ADDENDUM #2

Project Name:
Newton Correctional IPI Homes for Iowa Phase II
A/E Project # 02401959.001
DAS# 9239.02 & 9239.03
RFB 923902-01
Addendum #2
Dated: August 20, 2025

Addendum Number: 002

Project Name: Newton CF IPI Homes for Iowa Phase II

POLYLOK INFO BROCHURE
C6.1 SCALE NONE

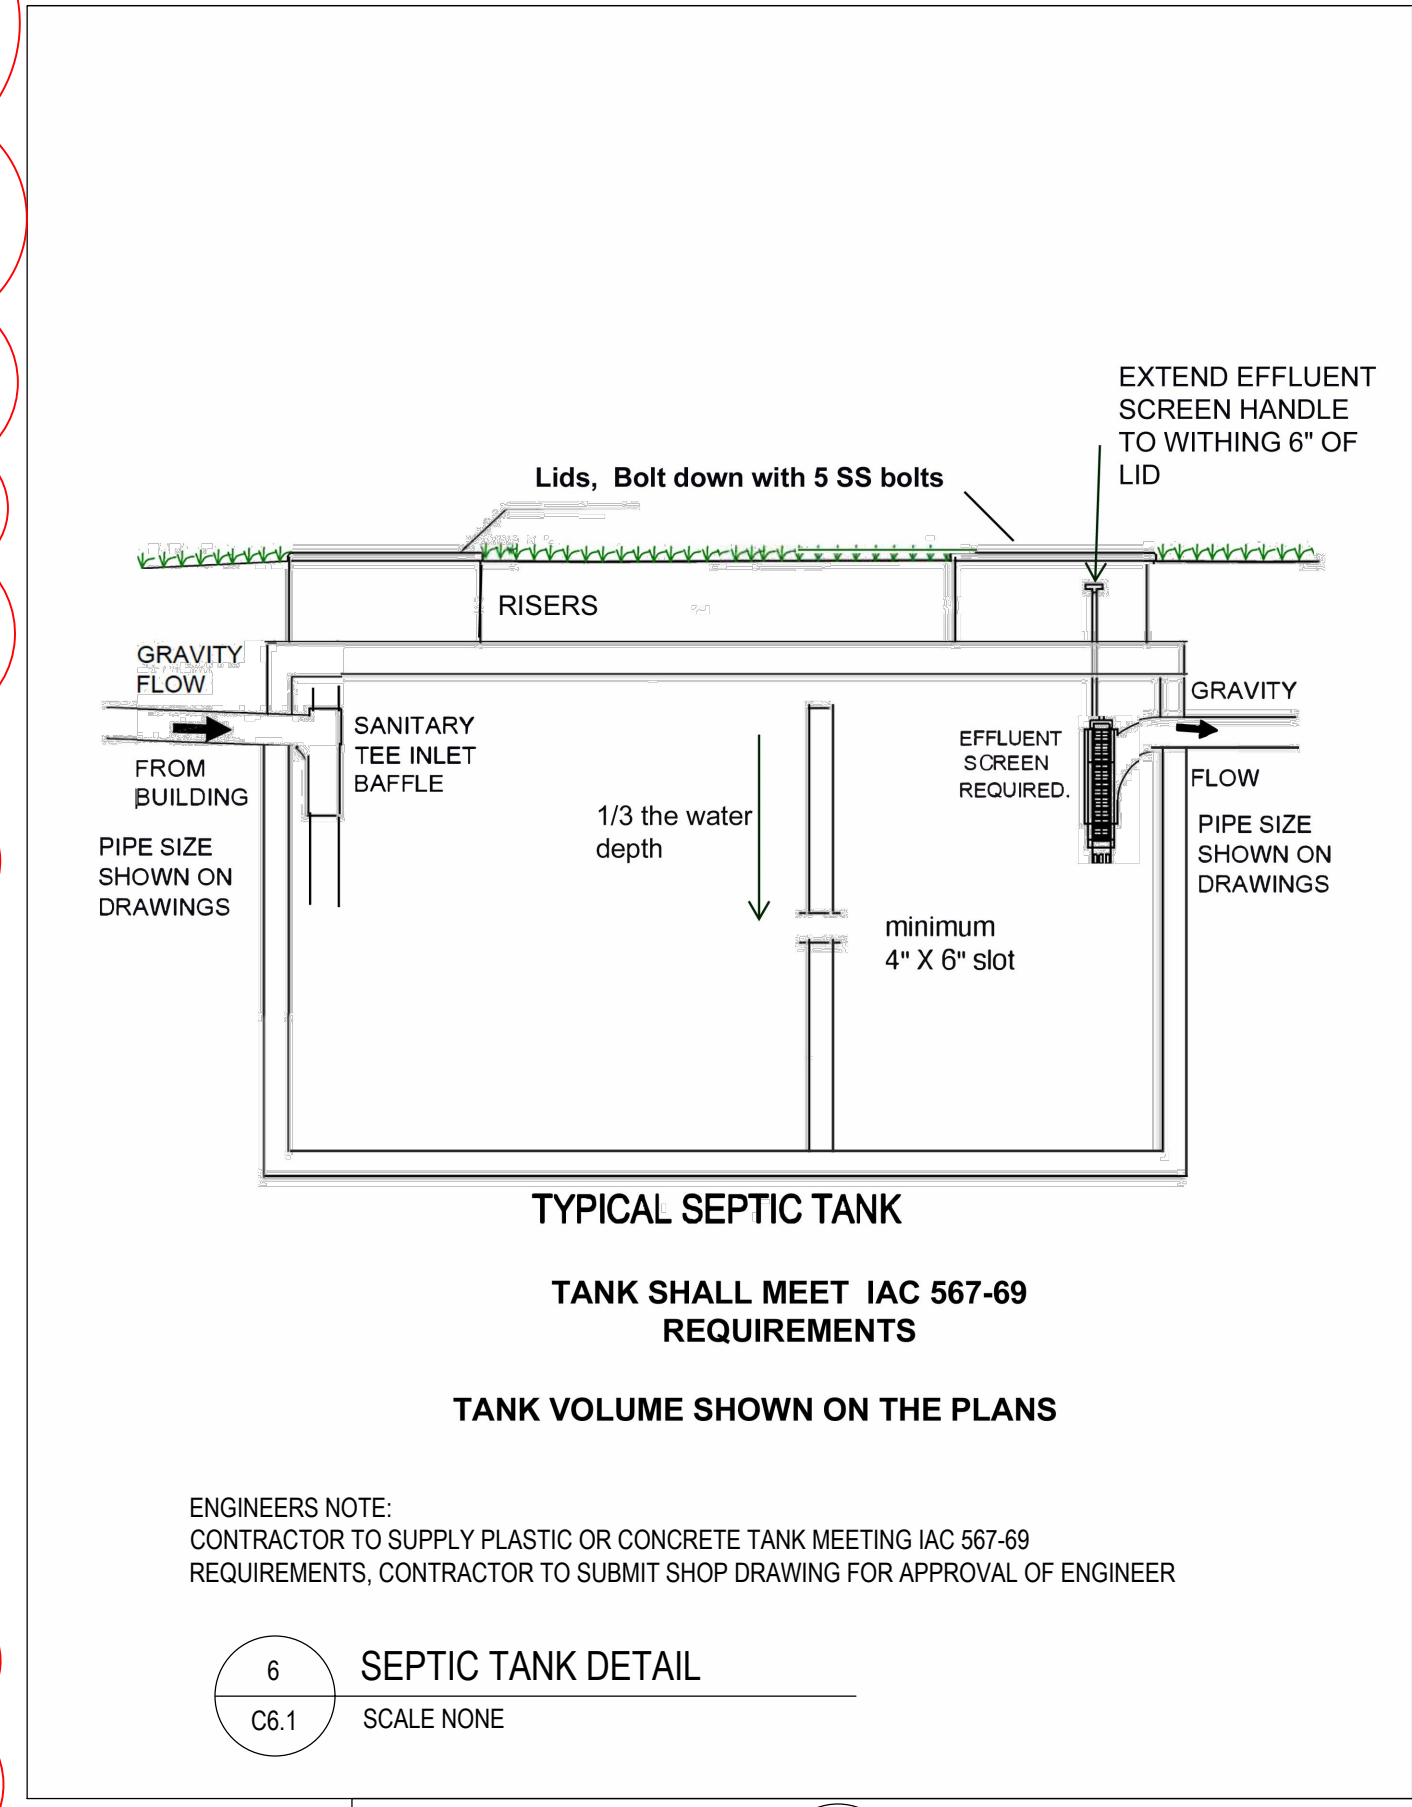
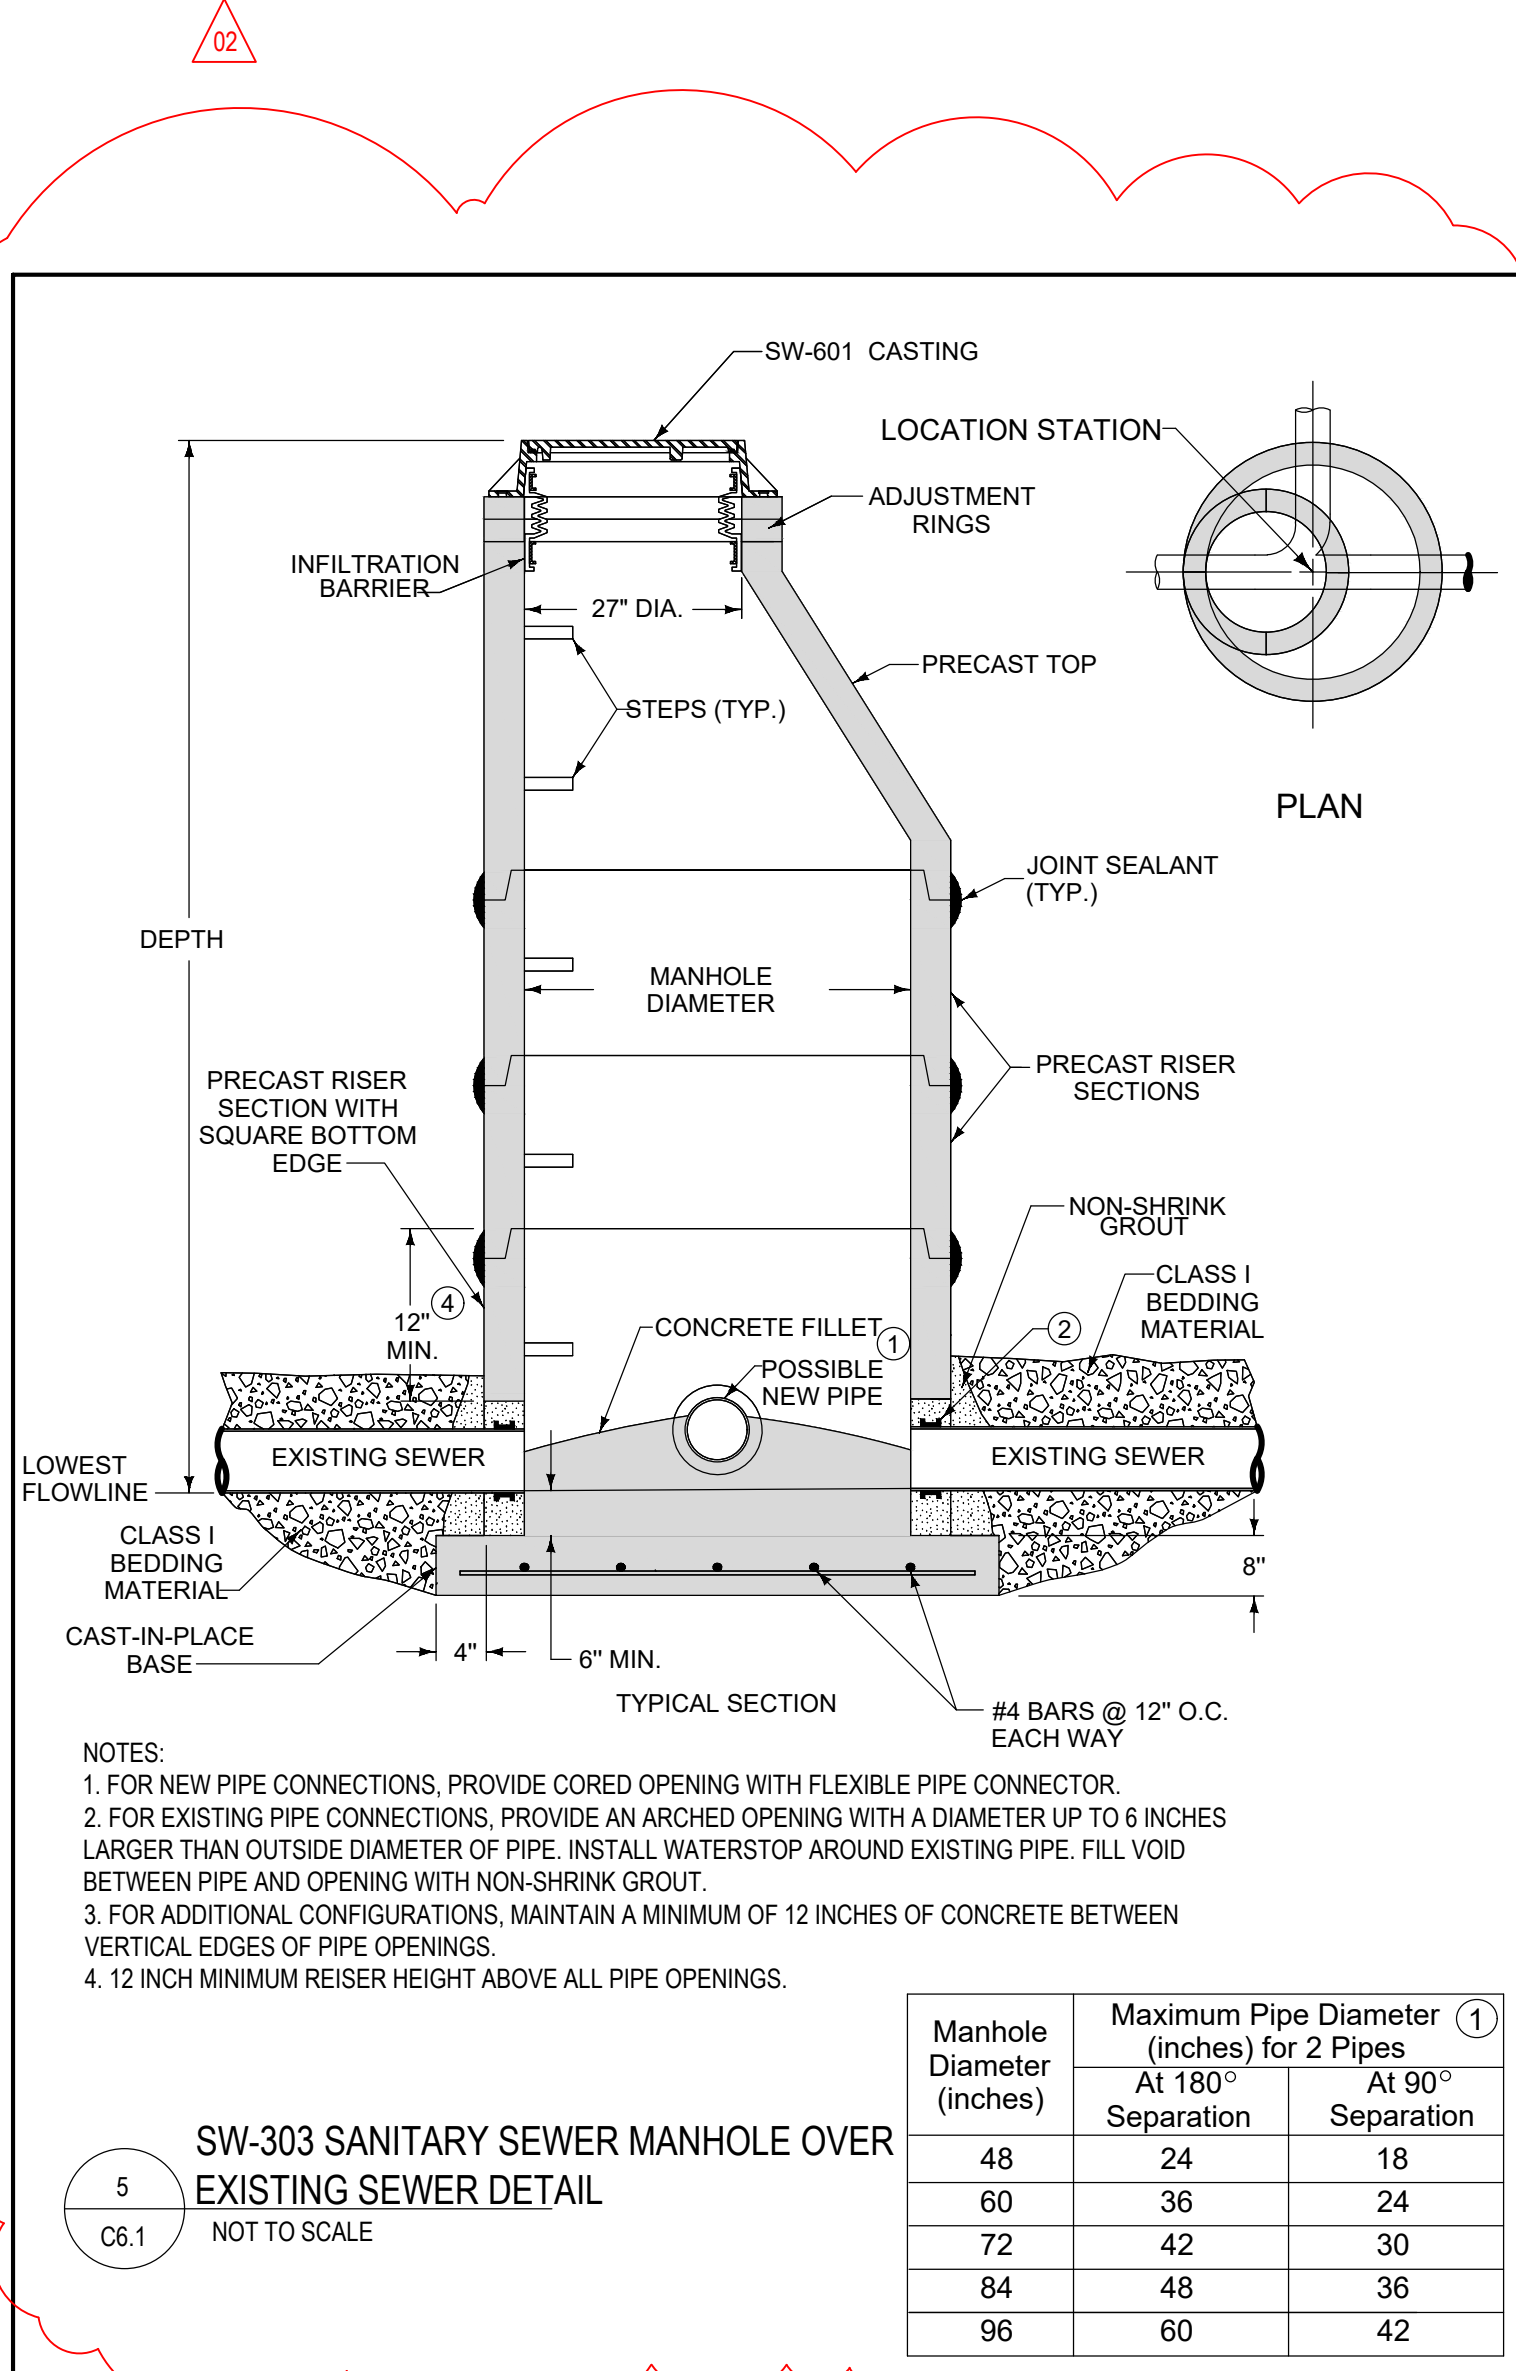
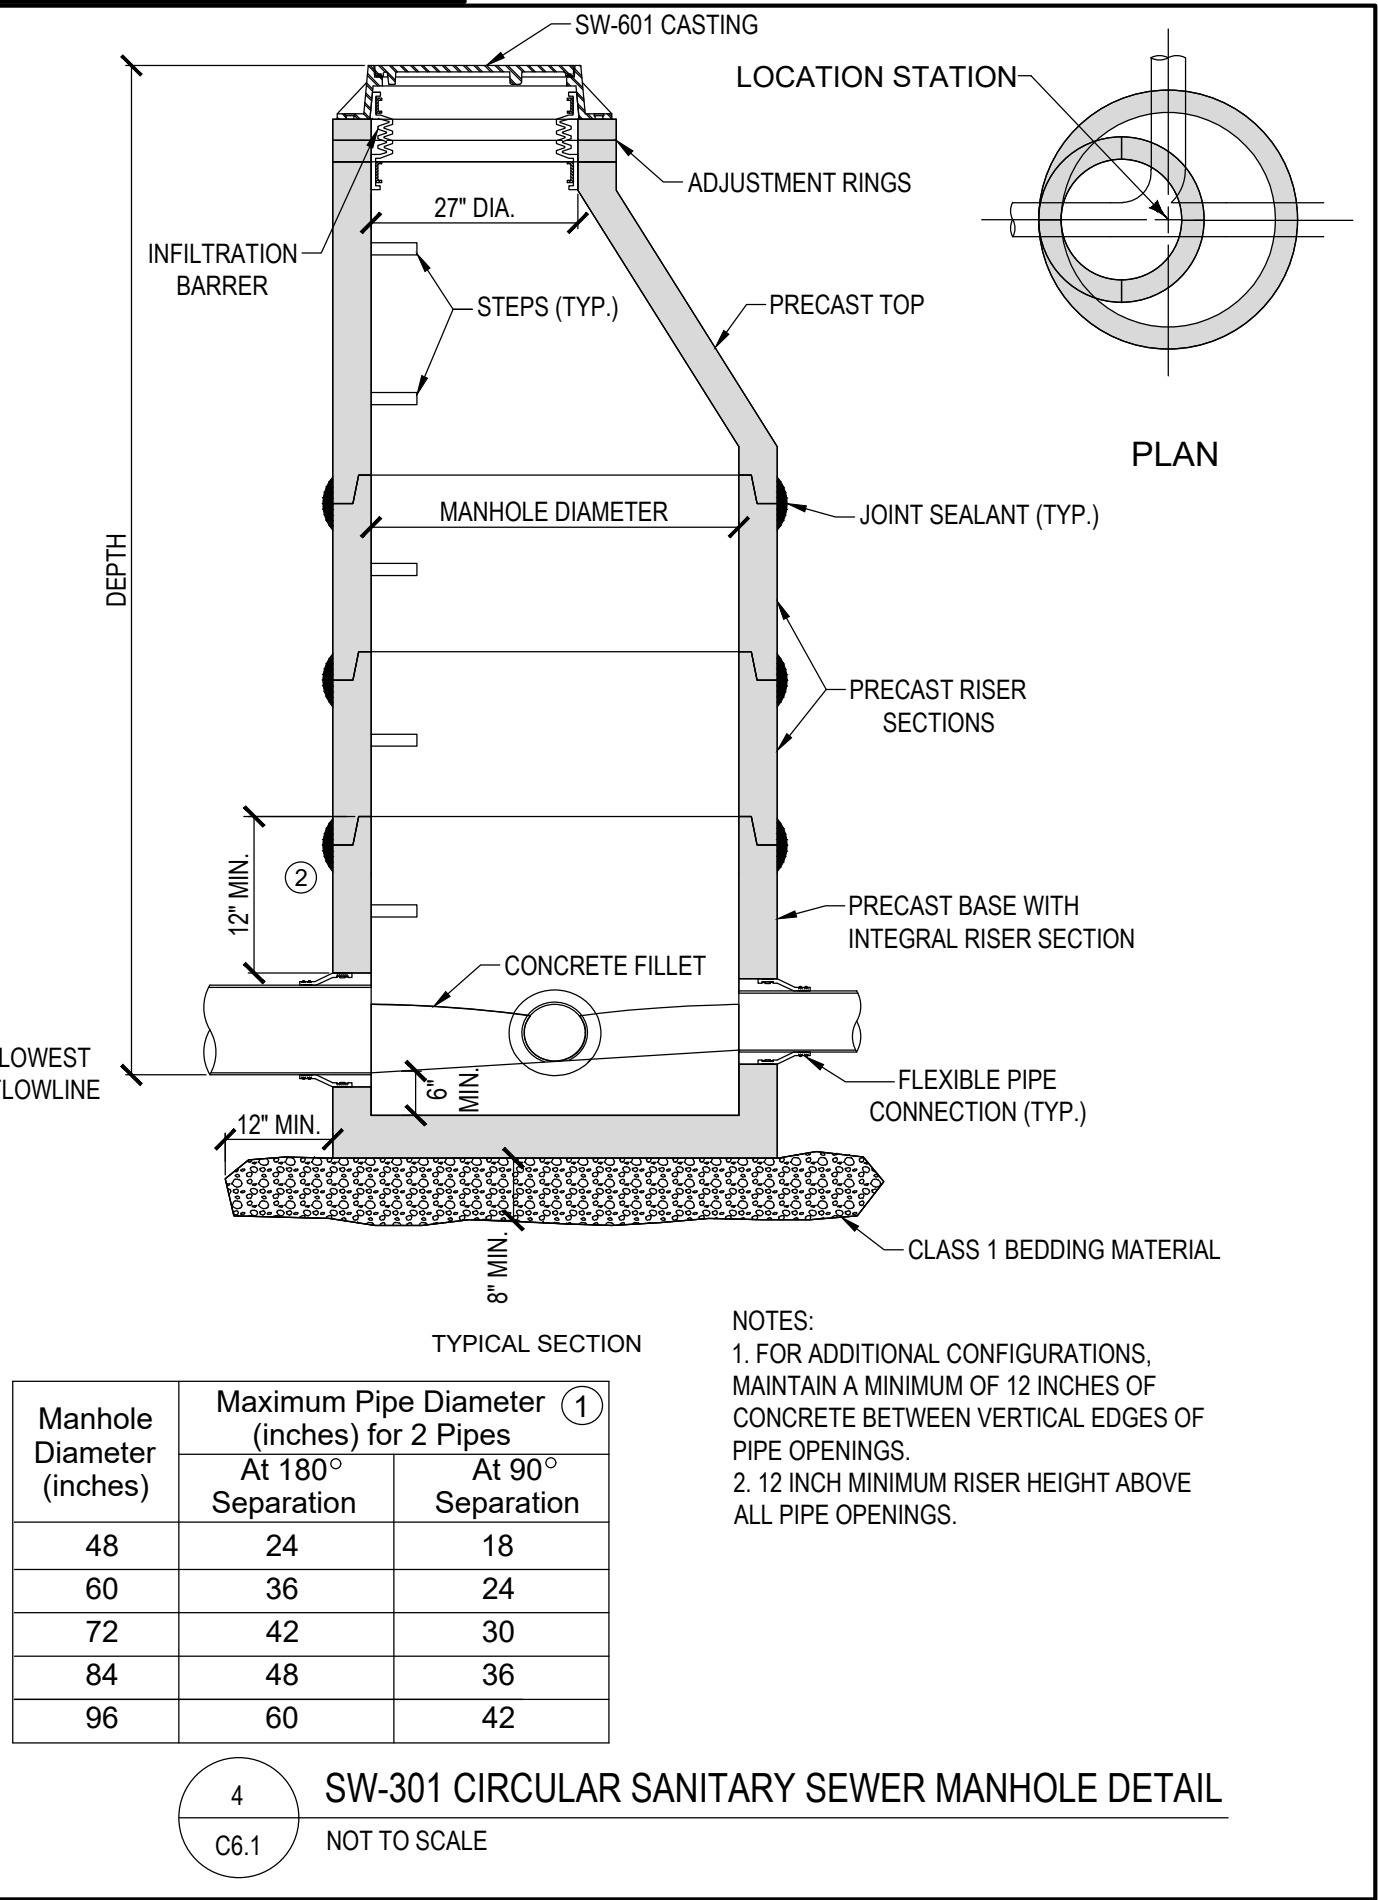
- Item No. 19 Added Detail for SW-303 Manhole to be placed over existing 8" Sanitary Line for new Connection.
